Big Boss Corporation Ltd. (Extension)

Holding#30 Sharabo, Kasimpur, Gazipur
(23.985604, 90.284023)
25 September 2023

Observations

Lack of Lateral Stability

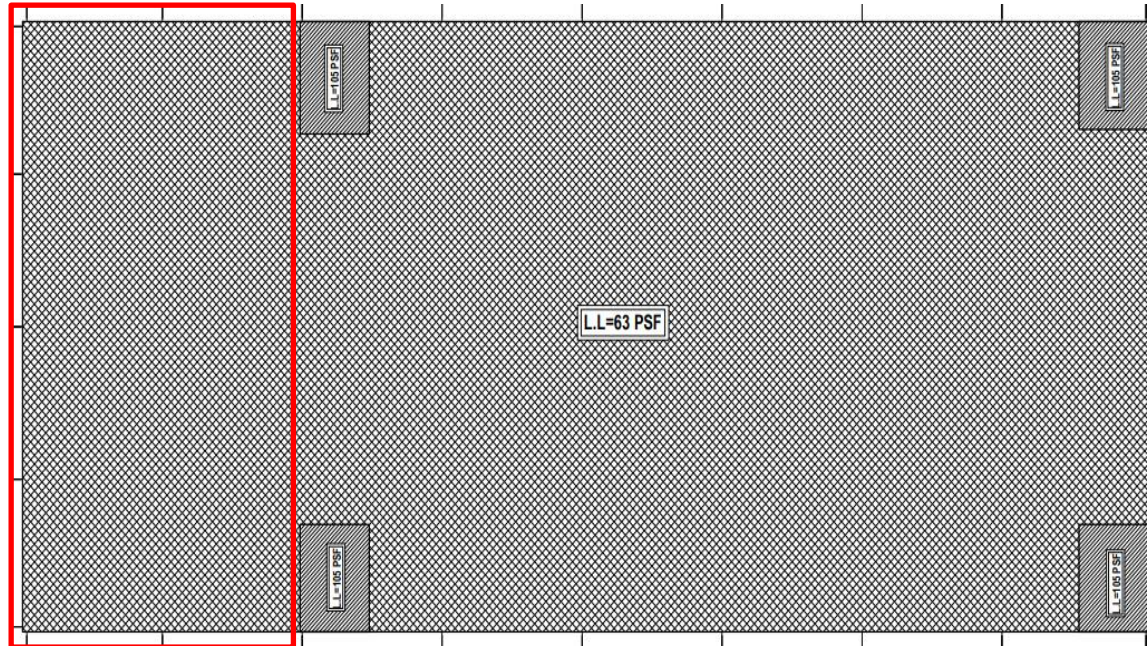
Shear connection in floor beam in both direction

Only roof bracing and compression member

Roof bracing and compression strut on roof and shear connection in both direction of 1st floor was observed . No vertical bracing was observed under floor or wall. Hence load transfer media from roof to foundation is incomplete. The building engineer is required to check the lateral stability of the structure as part of EA and suggest proper remedial actions accordingly.

Load plan doesn't comply with BNBC

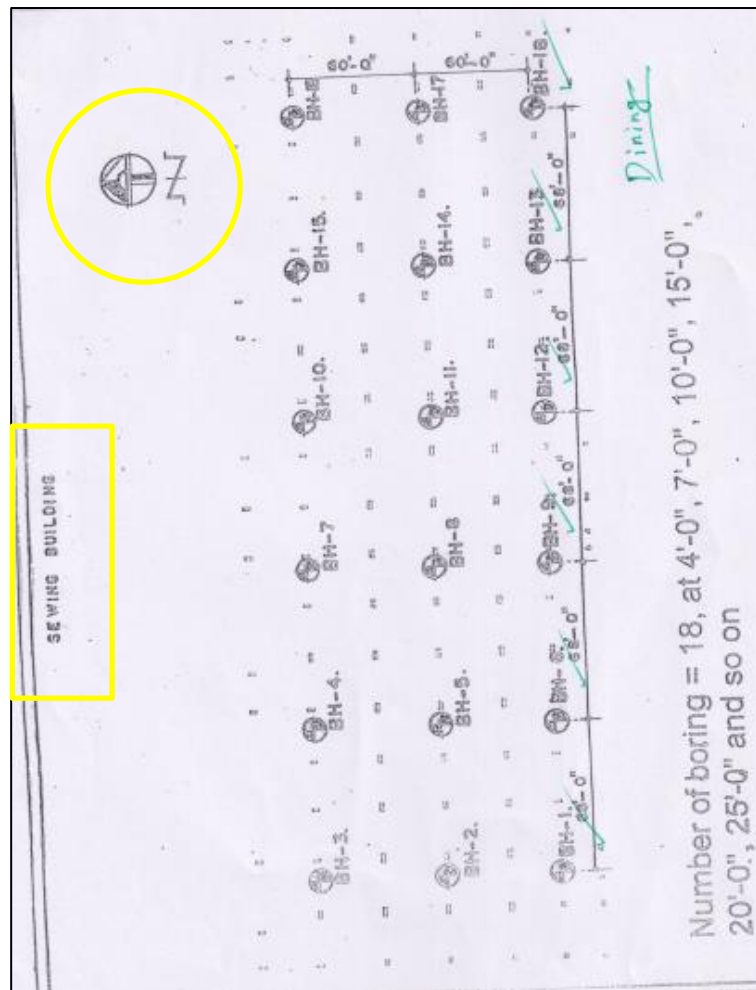
ASSEMBLY (Occupancy - E)	Library, auditorium, cinema, lecture hall, restaurant, bar, mosque, church (E1- E4)	1 Assembly room: with fixed seat without fixed seat	3.0 5.0	2.7 4.5
		2 Stages and projection room	5.0	4.5
Stadium, art gallery, grand stand, museum, gymnasium (E5)		3 Library :		
		Reading room – without book storage with book storage	2.5 4.0	4.5 4.5
		Stack room for book	6.5 ⁽³⁾	7.0
		1 With fixed seats	3.0	2.7
		2 Without fixed seats	5.0	4.5
		3 Corridor, stair and passage way	5.0	4.5

Min. 105 psf L.L . for prayer room.

Prayer room in 1st floor

Considered live load is 63 psf for prayer room on 1st floor in load plan

The design live load considered for 1st floor is 63 psf. Building engineer is required revised load plan as per BNBC Table 6.2.3 and revise the design report as well.

Soil-bearing capacity consideration

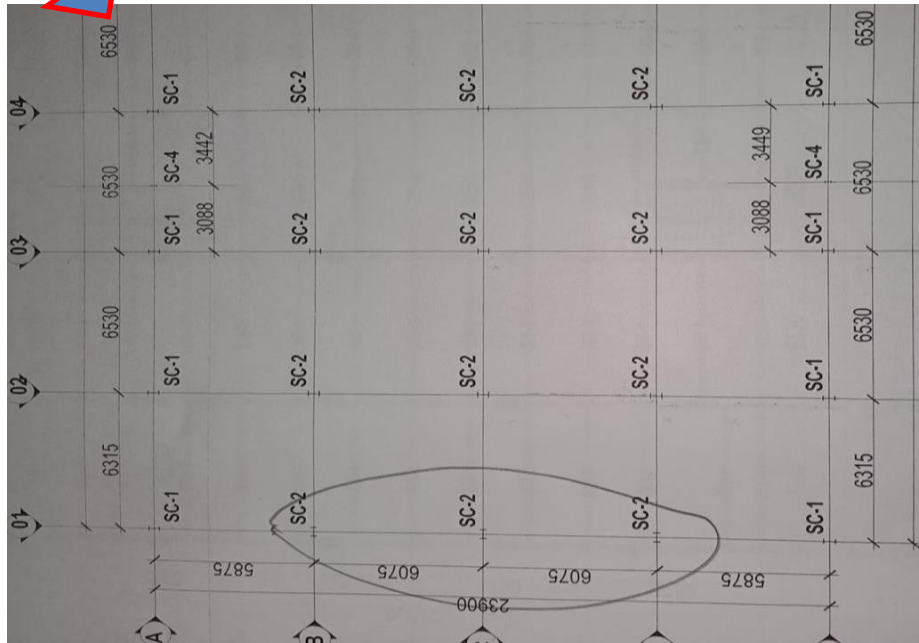
Bore hole location are for Sewing Building

The foundation adequacy check of this structure was done by using the data from different structures. Building engineer is required to check the foundation adequacy as per in-situ soil-bearing capacity.

Mismatch in as built drawing

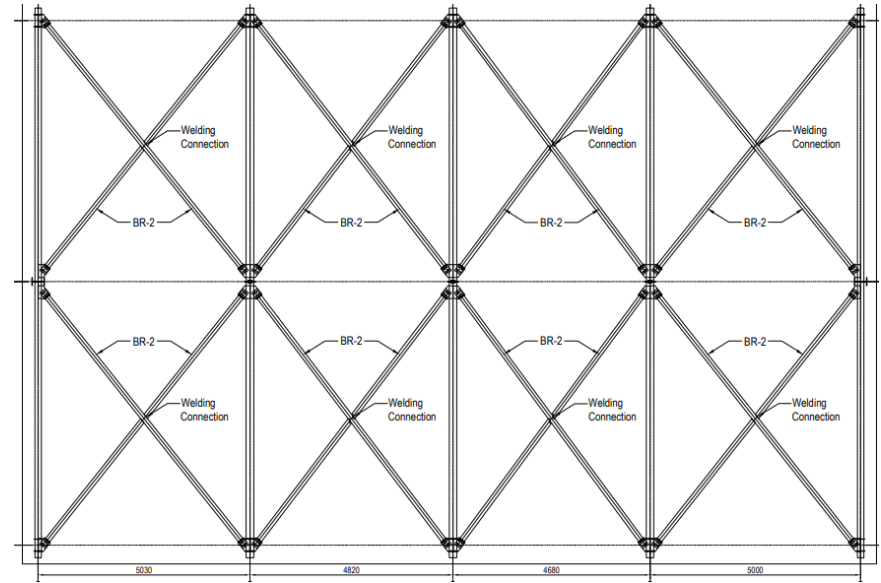
Columns shown in longitudinal direction

Columns found in transverse direction

Columns orientation were not matched with as built drawing. The building engineer is required to check the column orientation and update the as-built drawing accordingly.

Column orientation below floor

Rotated column above floor

During inspection, column above floor was observed in different orientation than column below floor. The building engineer is required to update the FEM model, check the vertical load transfer adequacy of the joint, and suggest proper remedial actions accordingly.

Plate sample location need to be filled

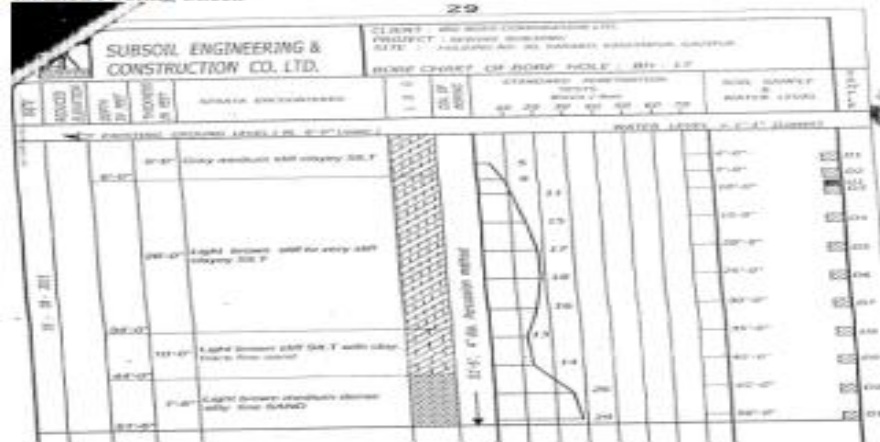
Sample has been taken from Column Flange

The factory has taken samples from steel member for plate tests. Building engineer is required to fill the sample location with adequate measures.

Design report needs to be updated

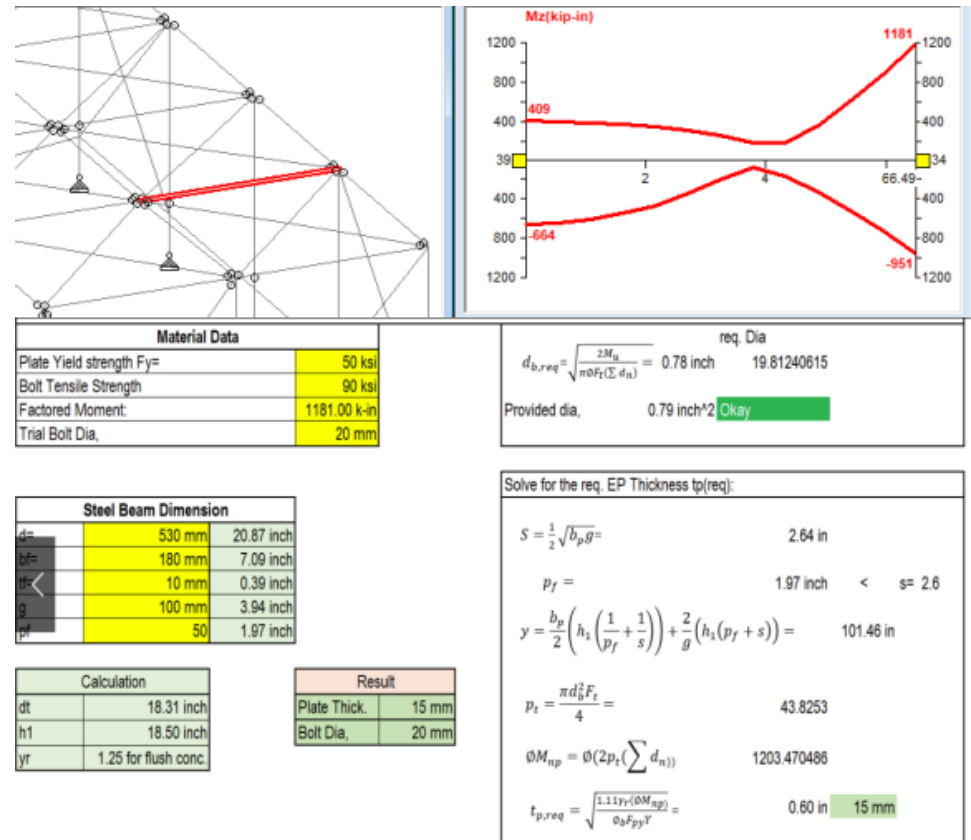
Isolated Footing Check

Terzaghi's Bearing capacity equation	
$q_{ult} = CN_cSc + \bar{q}N_q + 0.5B\gamma N_\gamma S_\gamma$	
C= Cohesion of soil	
B= Width of footing	
γ =Unit Weight of soil	
$\bar{q} = \gamma d$	
d= depth of foundation	
Sc, S γ = Shape factor (Sc=1.3 for Square footing)	
Nc, Nq, N γ =Bearing capacity factor from Chart	
γ =	120 lb/ft ³
ϕ =	0 for Clay soil
d=	5 feet
Nq=	1 from Chart
Nc=	5.7 from Chart
N γ =	0 for ϕ =0
(As per BNBC 2020 Appendix D)	
Unconfined Compression strength q_{uc} =12.5 N/60	
C $_{equr2}$	
N50	5
C=	31.25 Ksi/Sqmeter
or	652.5 Psi
q=	600 Psi
q $_{ult}$ =	5435 Psi
allowable=	2174 Psi (FS=2.5)
or	2.17 Ksf (With FS=2.5)

Foundation adequacy check from different soil test data

The foundation adequacy check of this structure was done by using the data from different structure. Building engineer is required to check the foundation adequacy as per in-situ soil bearing capacity.

column-rafter connection

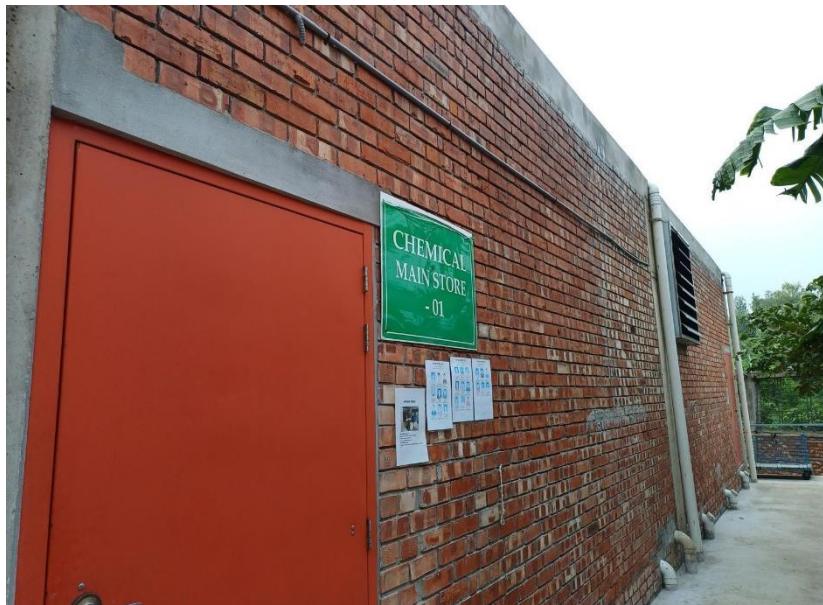
Joint design as rigid moment connection

The column rafter connection design as a moment resisting connection. However, the bolt arrangement in connection is not suitable for resisting moment. Building engineer is required to check the joint adequacy as per in-situ built condition and revise the design report as well.

As built drawing need to be revised

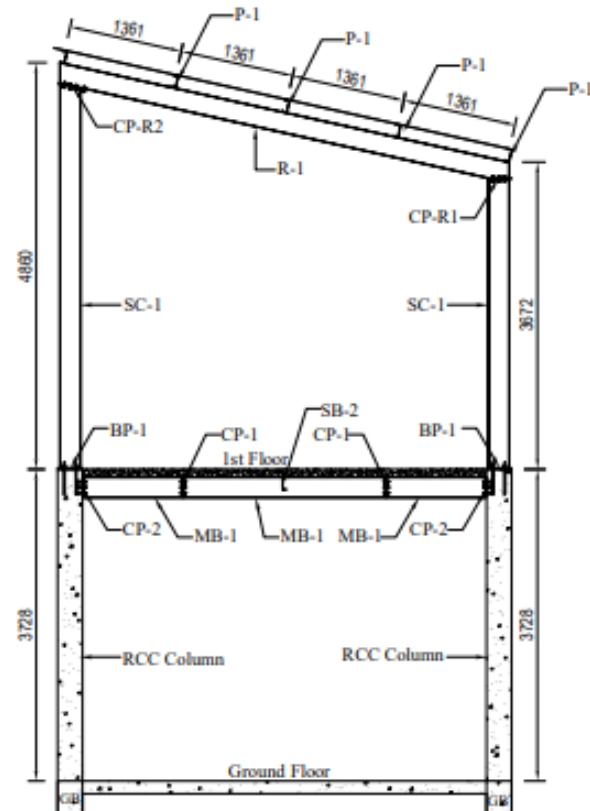
Single storey structure

Two storied structure in as built drawing

As built drawing was found for two storied structure with a stair. During inspection single story structure was observed with no stair. Building engineer is required to survey the structures thoroughly and update the as-built drawing.
